ADDENDUM NO. 1

**EDGEMONT SCHOOL DISTRICT
GREENVILLE & SEELY PLACE SCHOOLS
HVAC UPGRADES AND CAFETERIA RENOVATIONS**

DATE: January 24, 2023

This Addendum consists of three (3) Pages, Sketch SK-A1.0, revised drawings GVES M200, GVES E101, SPES MD100, SPES M100, SPES M101, SPES M102, SPES M103, SPES M104, SPES M200, SPES M203, SPES M300, SPES M400, SPES ER100, SPES ER104, SPES E100, SPES E103, and SPES E104.

2 DISCONNECT UNISTRUT RACK DETAIL
SCALE: 1/2" = 1'-0"

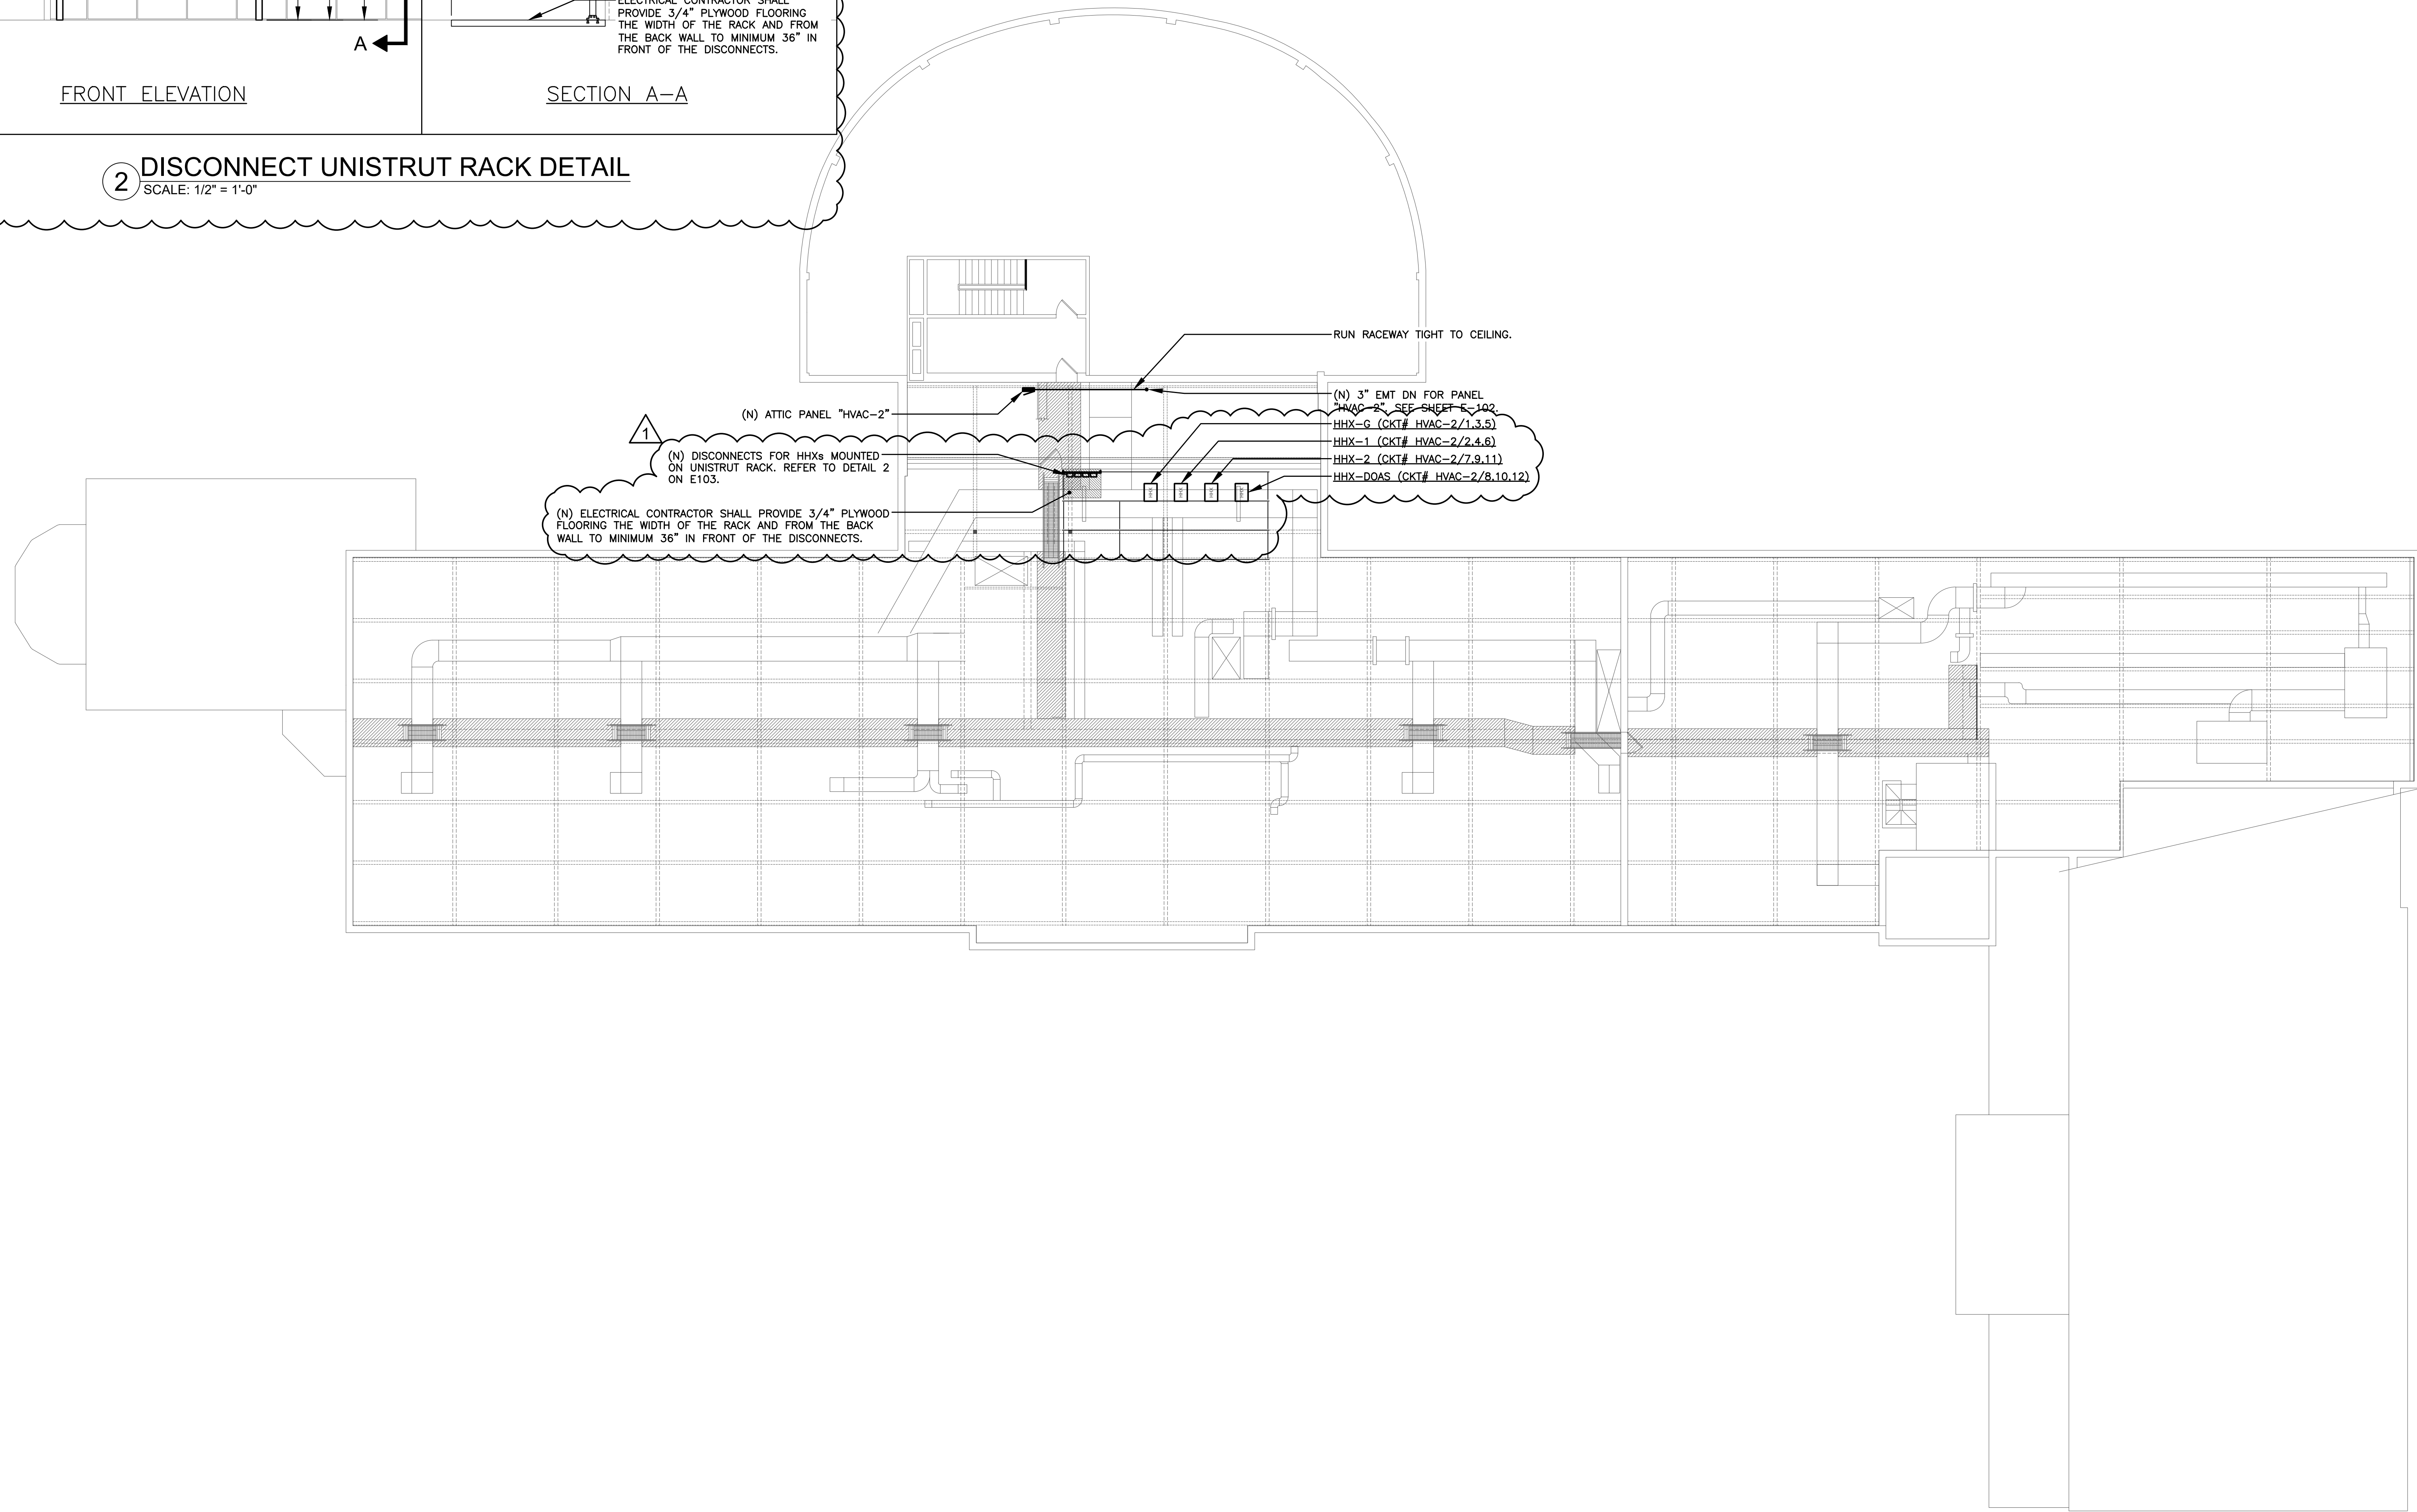
DRAWING SPES E103 – ATTIC ELECTRICAL PLAN

ADD Detail 2, Disconnect Unistrut Rack Detail as shown on drawing attached to this addendum.

1-24-2023	ADDENDUM 1
1-06-2023	BID
DATE	ISSUED TO
SHEET SIZE 30"x42"	DRAWING NO. SPES E104
SCALE AS NOTED	FILE NO. 21434.01
DRAWN BY LFG

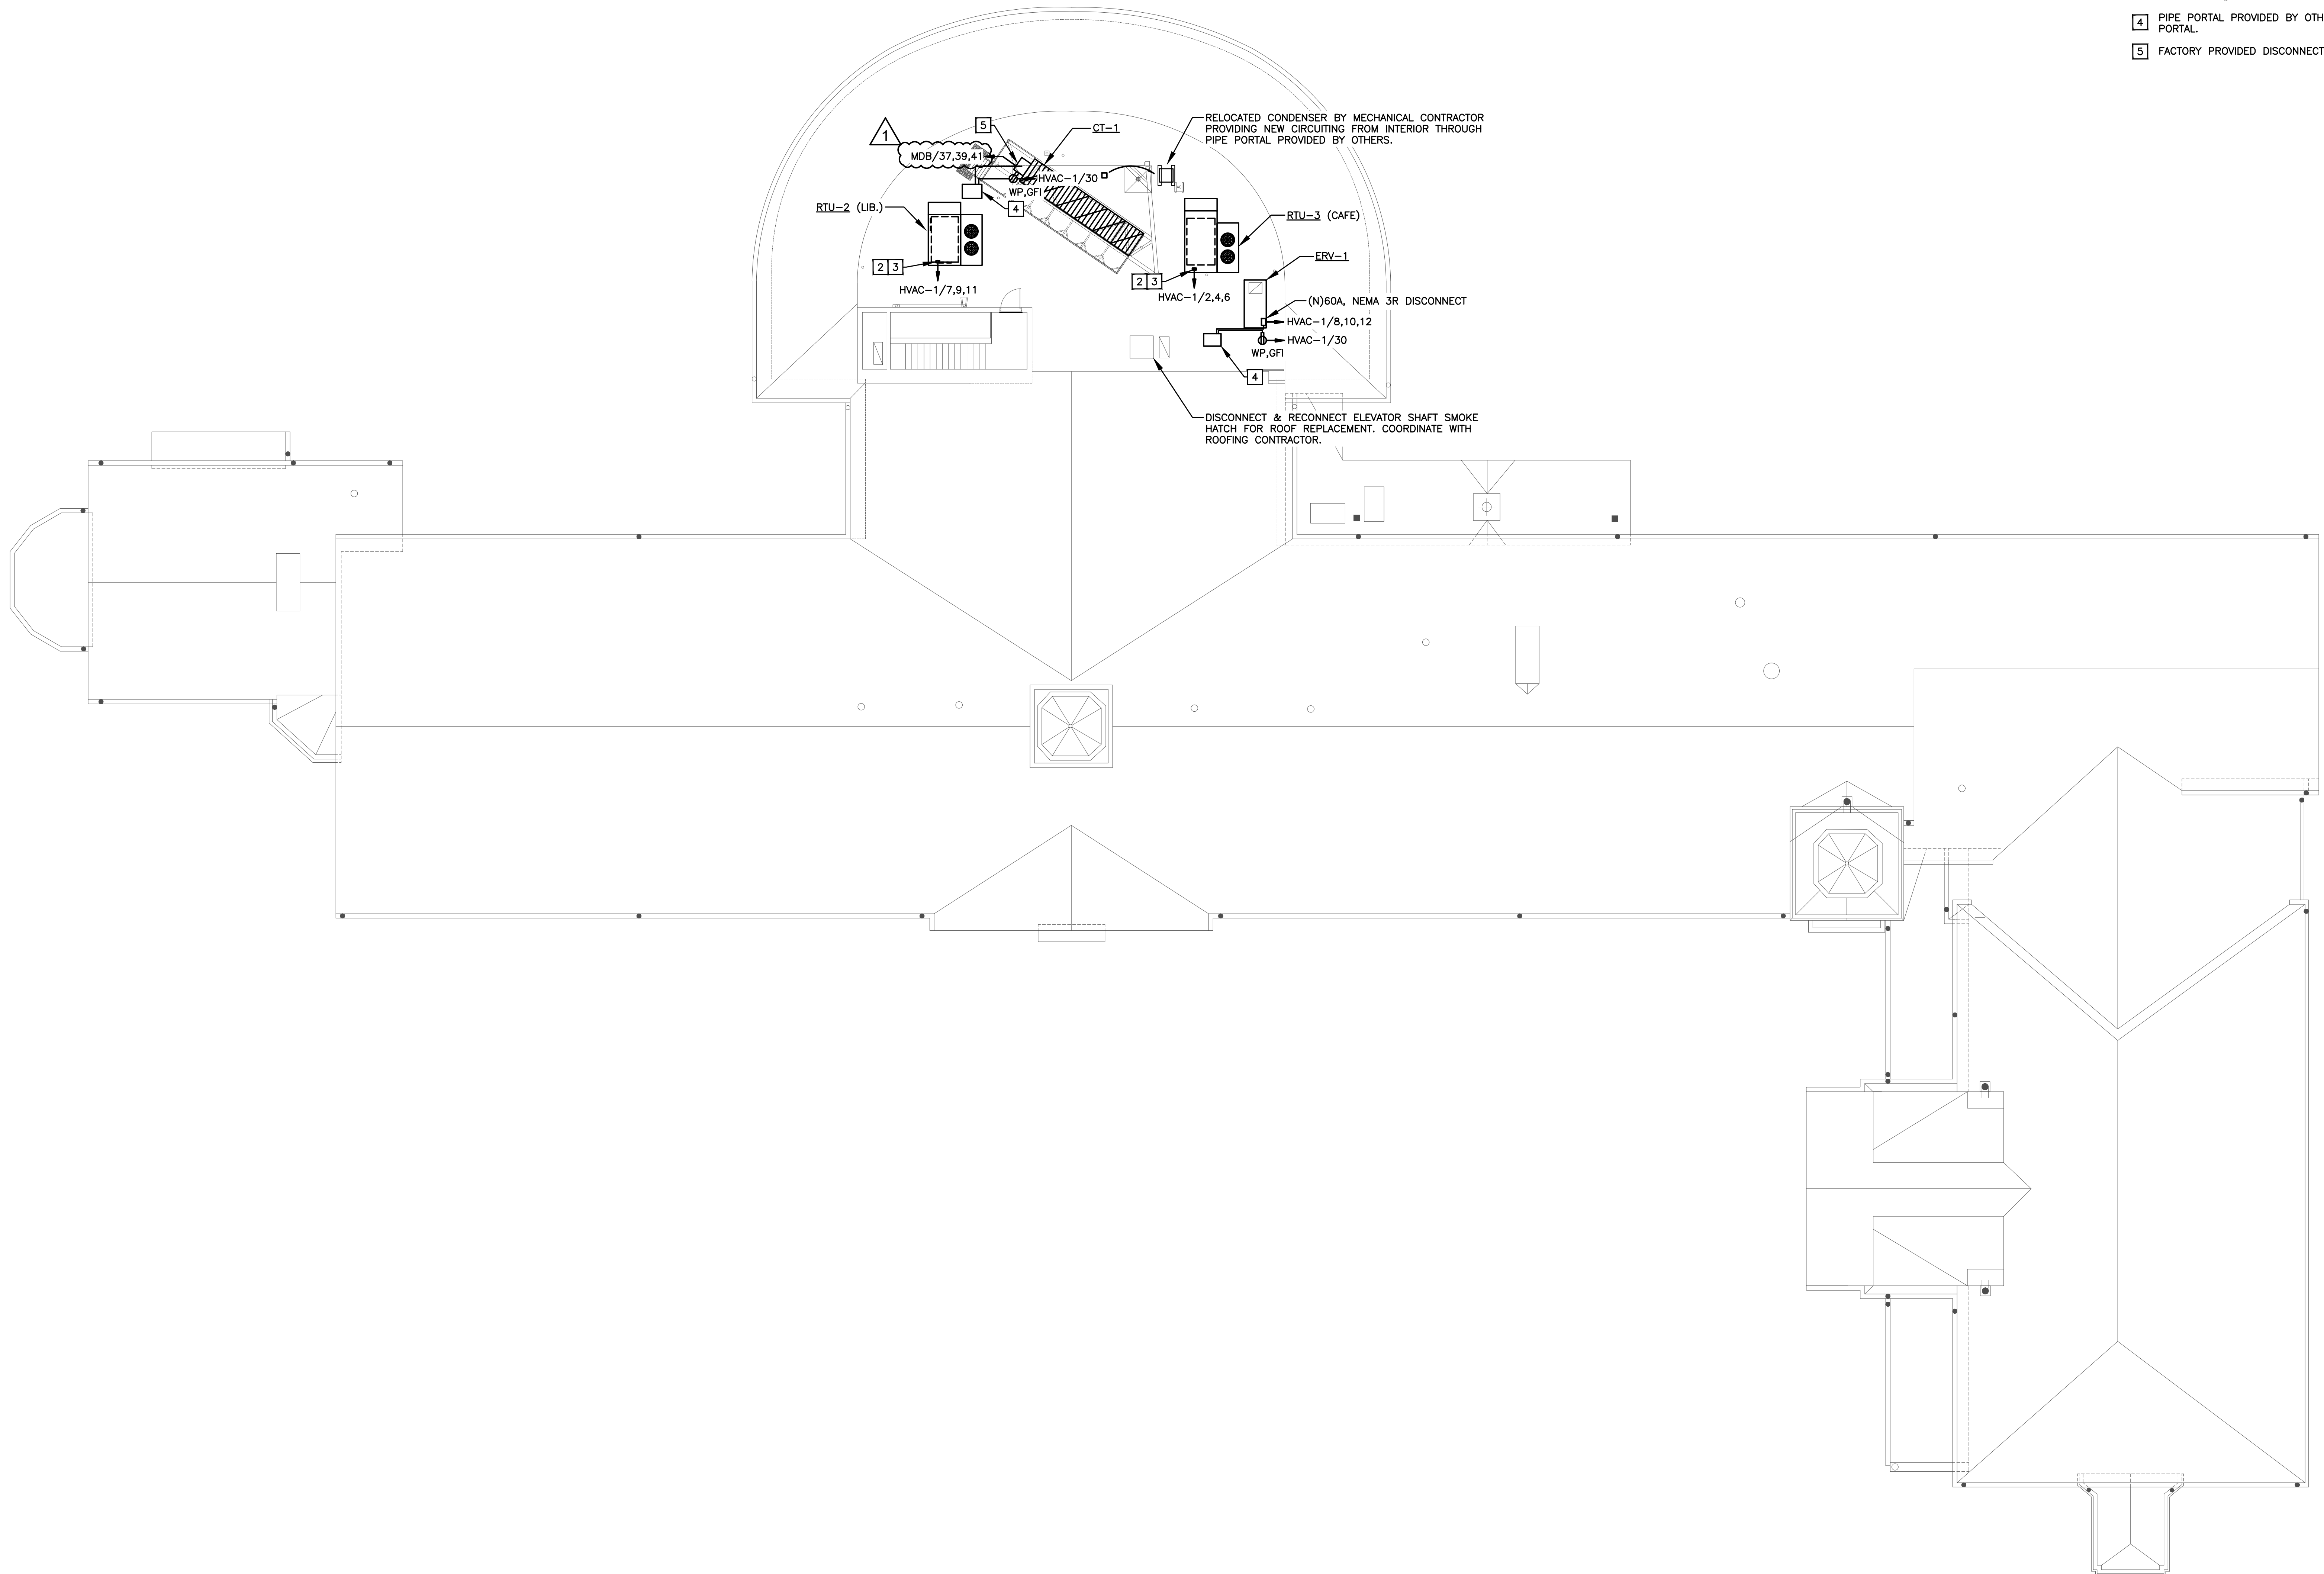
DRAWING SPES E104 – ROOF ELECTRICAL PLAN

ADD note as shown on drawing attached to this addendum.

- 1 UNUSED
- 2 CONDUIT UP WITHIN CURB INTO EQUIPMENT. ELECTRICAL CONTRACTOR SHALL WIRE FACTORY FURNISHED NON-FUSED DISCONNECT SWITCH.
- 3 CONTRACTOR SHALL WIRE GFCI RECEPTACLE ON UNIT TO PANEL HVAC-1 CKT#30. ROUTE POWER THROUGH CURB.
- 4 PIPE PORTAL PROVIDED BY OTHERS, ROUTE CONDUIT THROUGH PIPE PORTAL.
- 5 FACTORY PROVIDED DISCONNECT SWITCH.
